TECHNICAL NOTE

PROJECT: Land west of Pagham Road – Approval of Reserved Matters (planning references: P/155/21/RES and P/158/21/RES)

REPORT: 2152/TN/03 – Response to highway officer consultation dated 30th November 2021

REFUSE VEHICLE SWEPT PATH ANALYSIS - COMMERCIAL USES

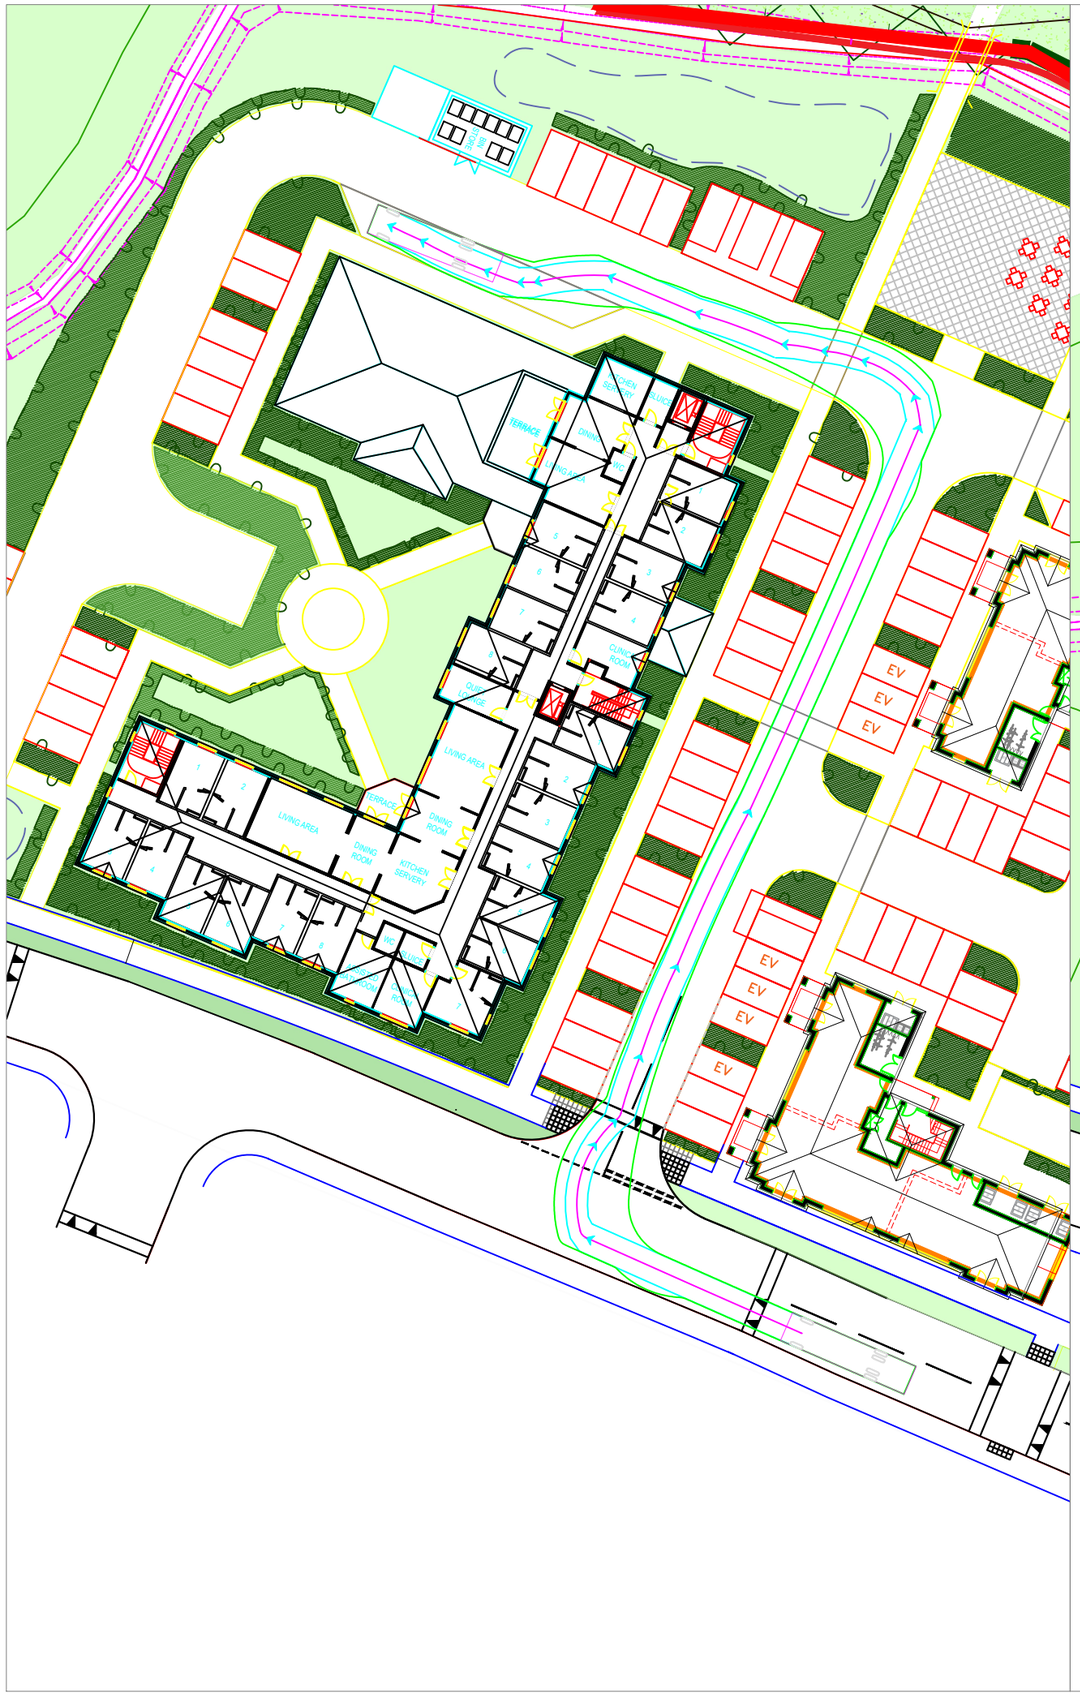
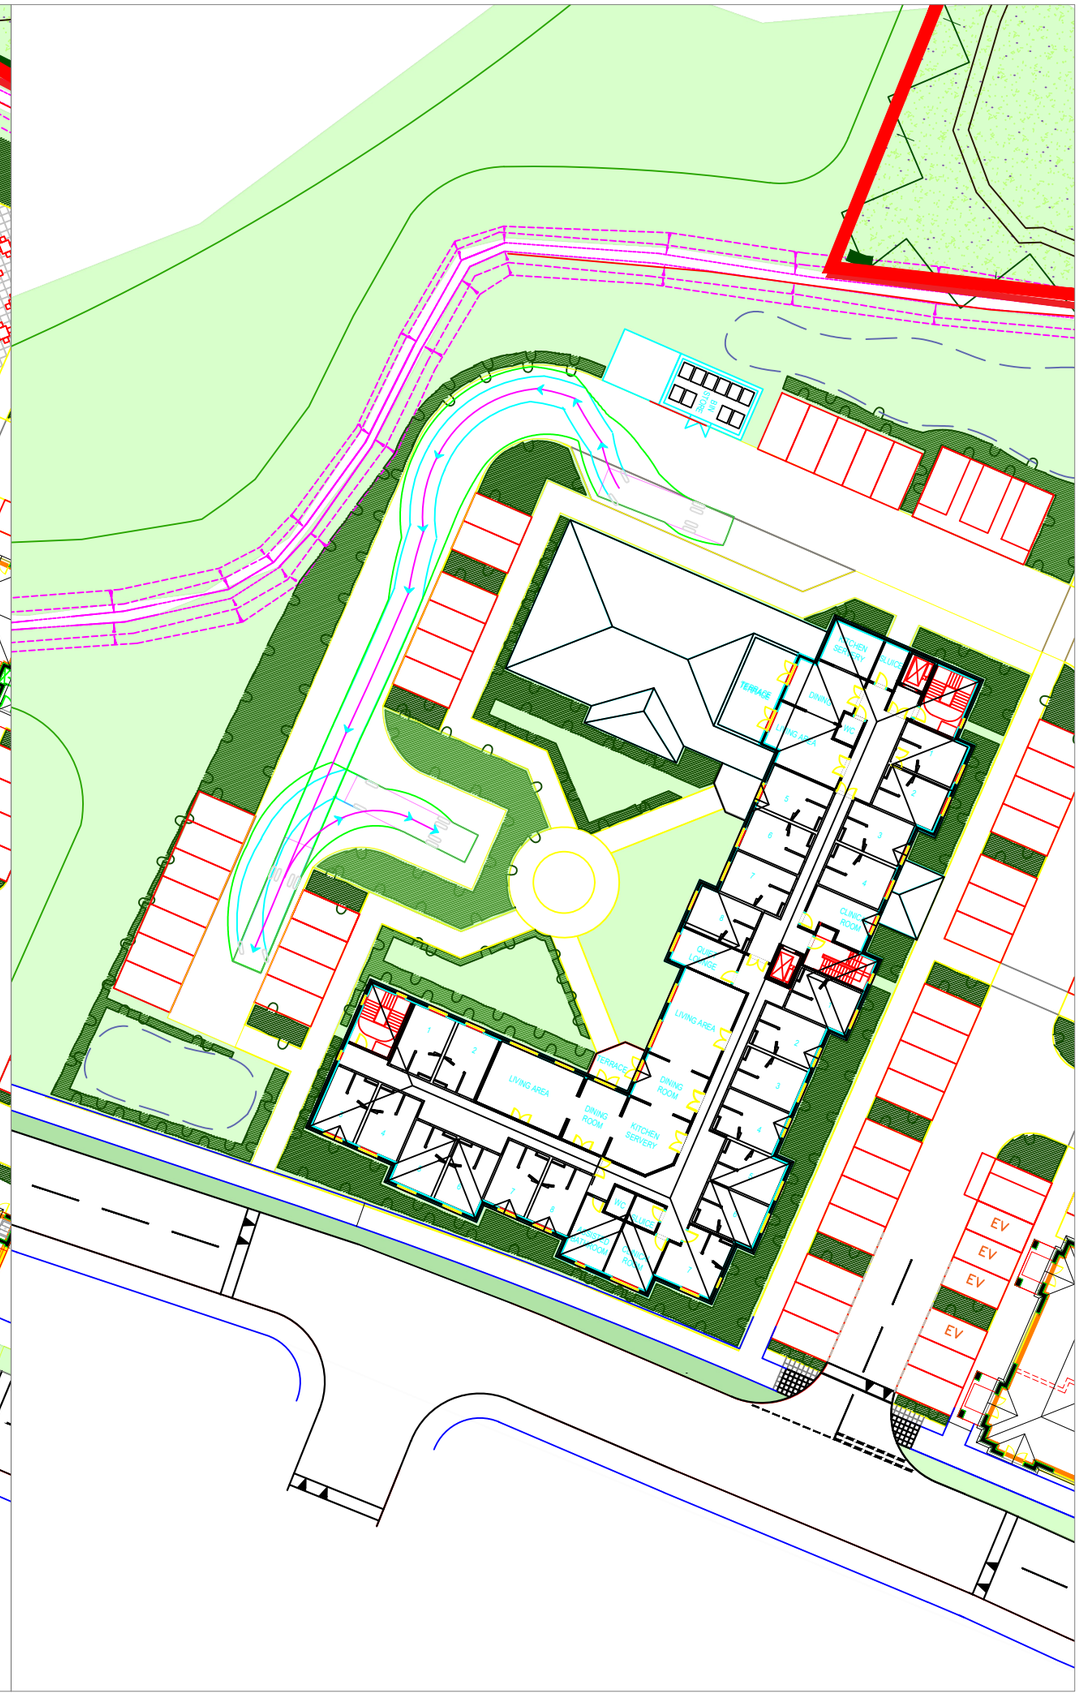
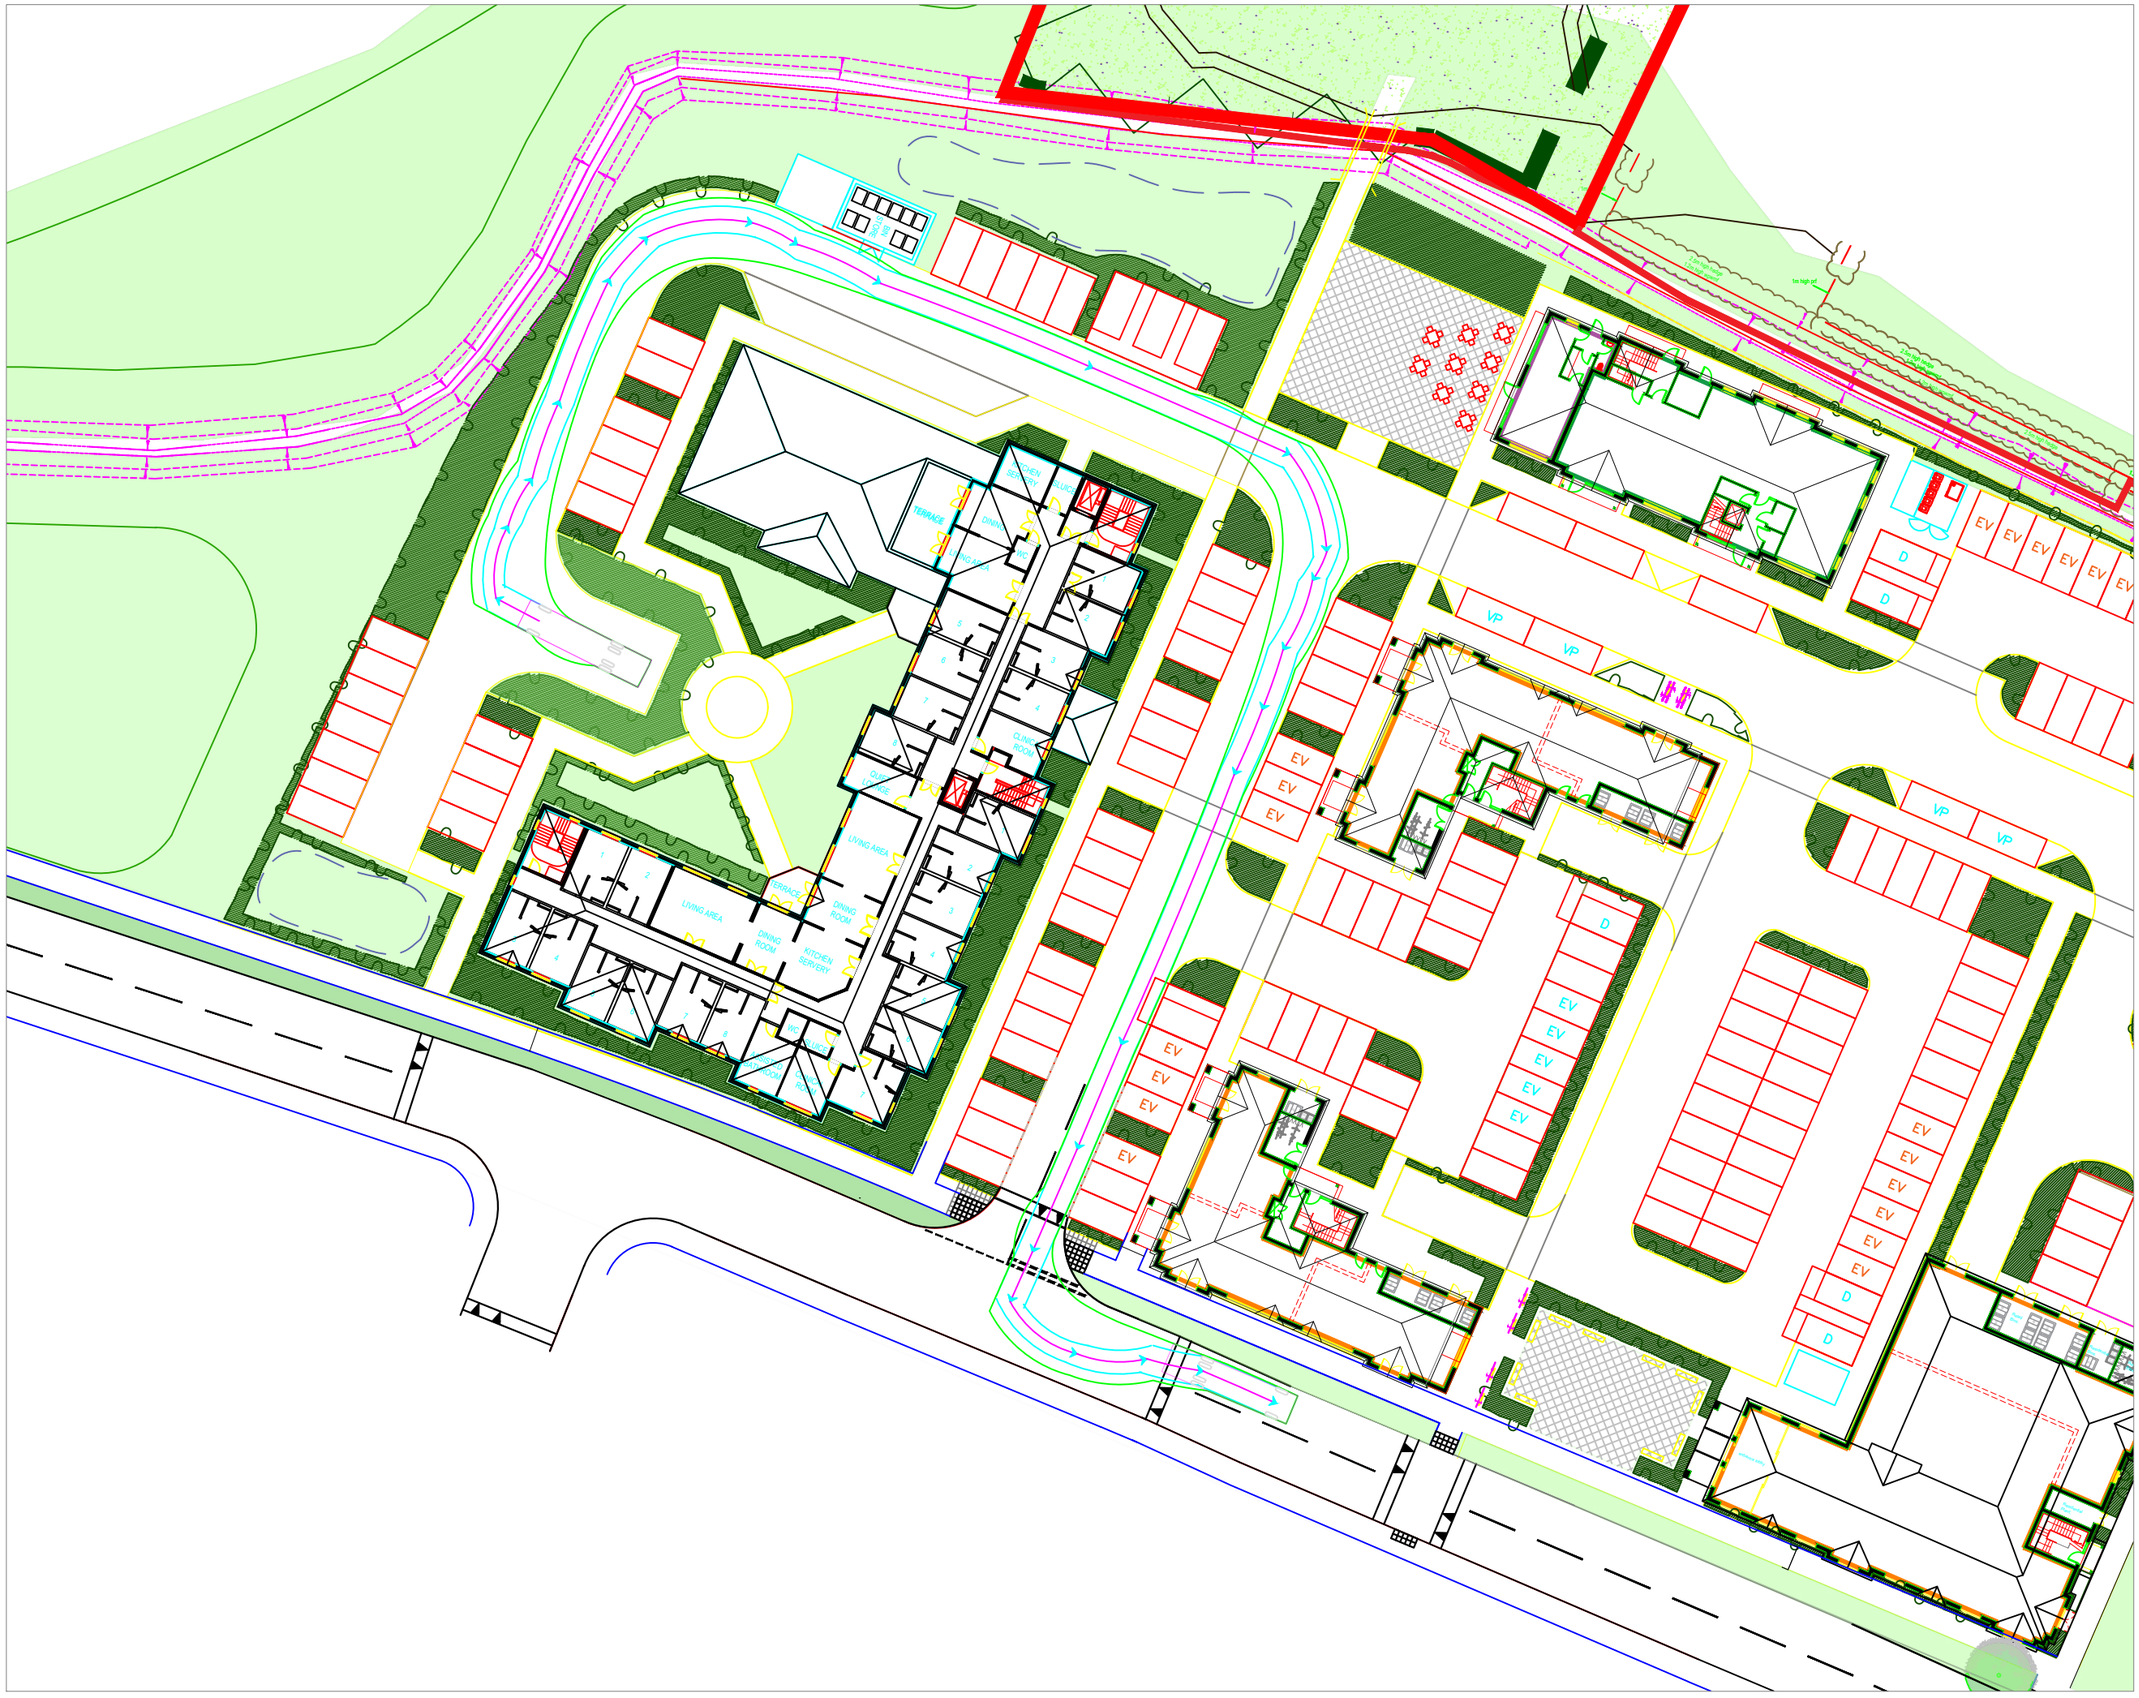
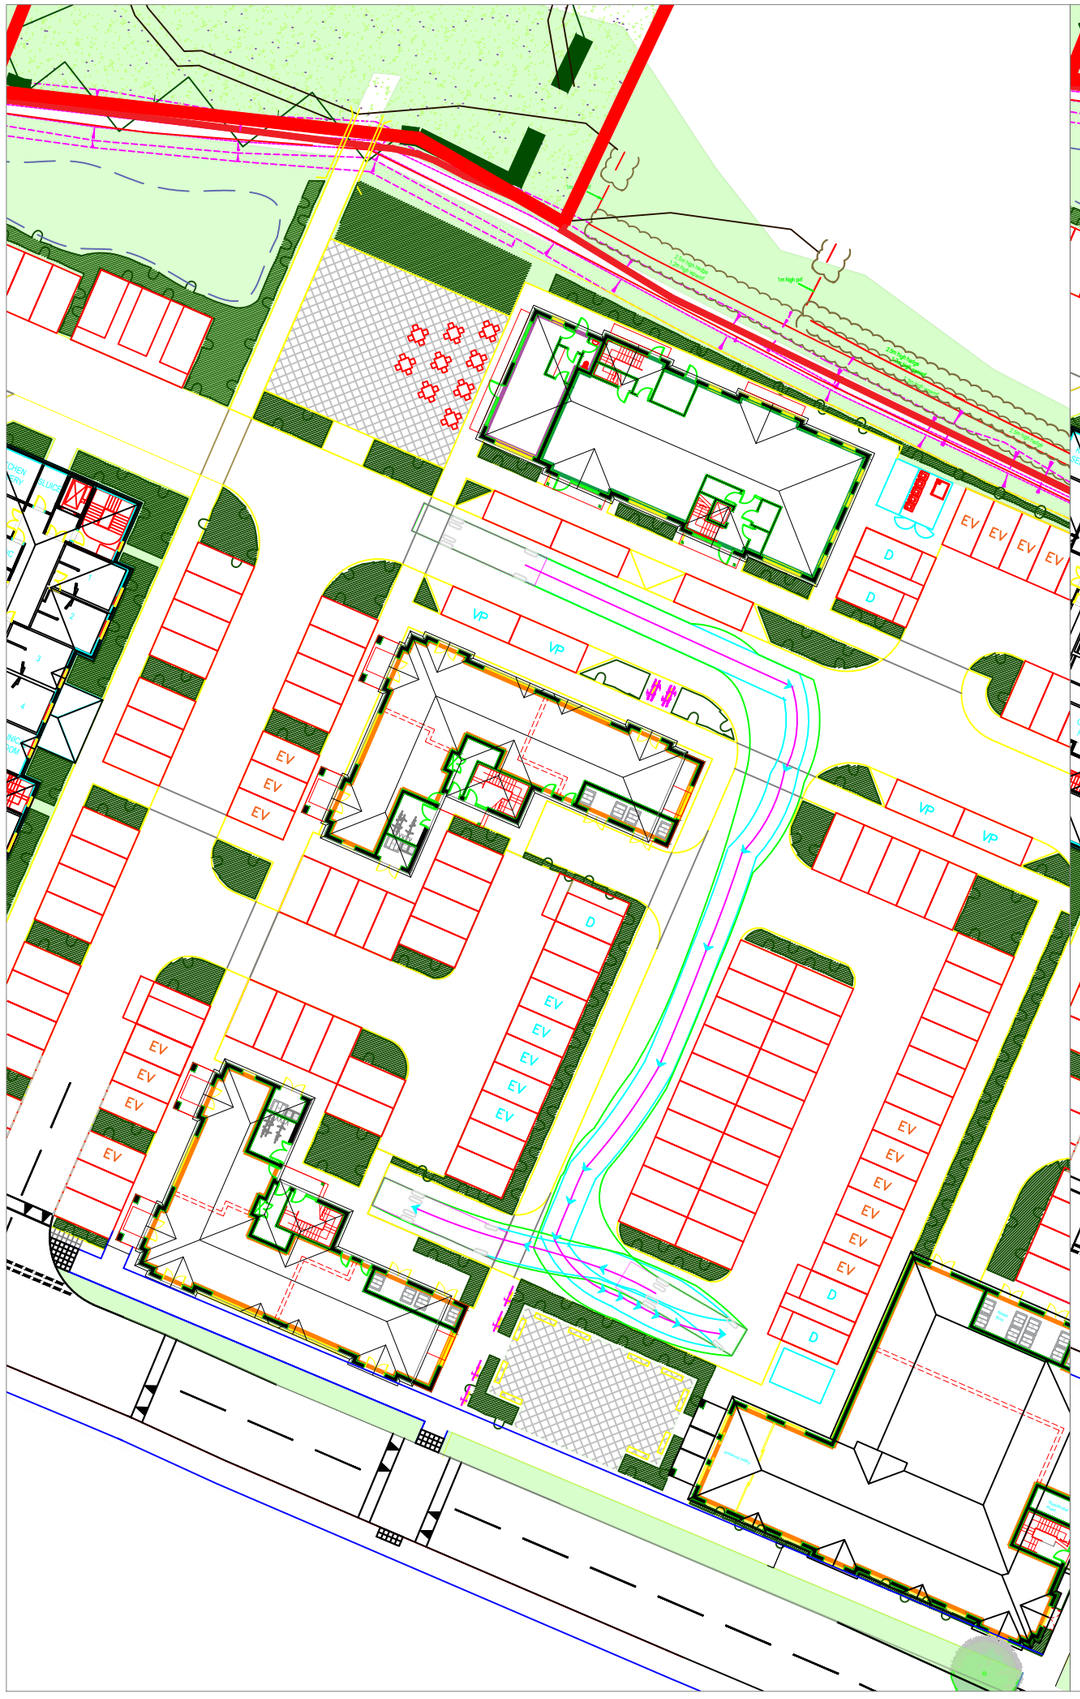
Along the frontage of the local centre and school the spine road is shown with a width of 7.3 metres, further justification of this width should be provided to show that it is compatible with the 20mph speed restriction proposed

In terms of more detailed matters, WSCC Highways have previously questioned the need for the 7.3 metre wide road across the school frontage; this road width is considered at odds with the 20mph design speed proposed. This aside, very limited consideration appears to have been given particularly to the potential demands arising from the school site (i.e. parent parking, dwell space/footway widths along the frontage) or the need for school safety zone type features (e.g. enforceable restrictions (i.e. 'School Keep Clear and No Waiting At Any Time (which may need to be wrapped around onto Pagham Road also). The applicants for P/153/21 and the current application will need to incorporate such elements into the design.

11. Swept path analysis for an 11.0 metre refuse collection vehicle was provided within the Transport Statement that supports the application and is provided at **Appendix 2** for ease of reference. From this it can be seen that the road width is required to serve the local centre via the proposed access. It also likely that a similar road width would be required, in any event, for school buses/coaches (including those required for school trips).

12. The 7.3 metre road width is proposed to ensure that large vehicles are able to conveniently and safely serve the local centre and school sites. Speed tables form part of the spine road design to ensure compatibility with the 20mph speed restriction. The S278 approval for the spine road/Pagham Road junction confirms the spine road width to be 7.3 metres.
